Product Change Notification / SYST-28DSPA532

ERRATA - PIC18F27/47/57Q43 Silicon Errata and Data Sheet Clarifications

PIC18F27/47/57Q43 Silicon Errata and Data Sheet Clarifications

1.7 Module: Universal Asynchronous Receiver Transmitter (UART)**1.7.1 UART TXDE Signal May go Low Before The STOP Bit Has Been Entirely Transmitted.**

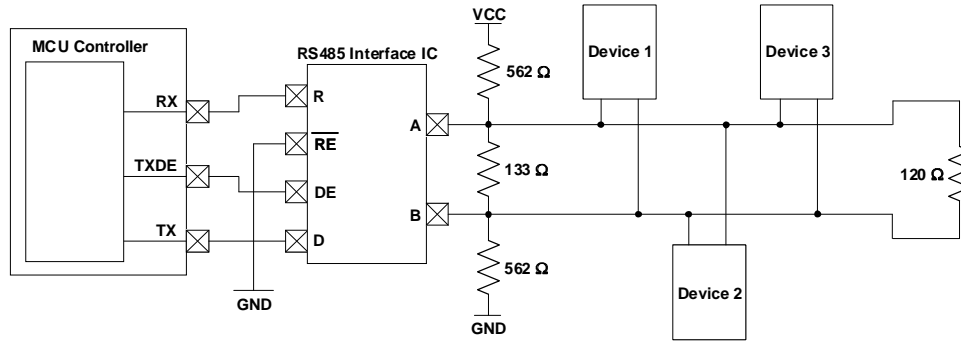
The UART Transmit Drive Enable (TXDE) signal could potentially transition into a low state before the UART STOP bit has been entirely transmitted due to the effects of parasitic capacitance on the TX line. In some applications, this could result in communication being prematurely terminated due to the TXDE bit going low before the STOP bit has had enough time to settle.

In order to ensure that the STOP bit settles into its final logic state before the TXDE signal transitions low, a biasing circuit can be implemented. A biasing circuit allows the TX line to either be driven high or low, rather than being left in a floating tri-state mode where prolonged rise or fall times could lead to communication being disrupted. This bias circuit should only be implemented on one end of the serial bus, and a termination resistor should be used on the other end. The figure below shows an example of a bias circuit that can be used to achieve this.

Please note that the resistor values used in this circuit are recommendations, and that the actual resistor values required may vary based on the application.
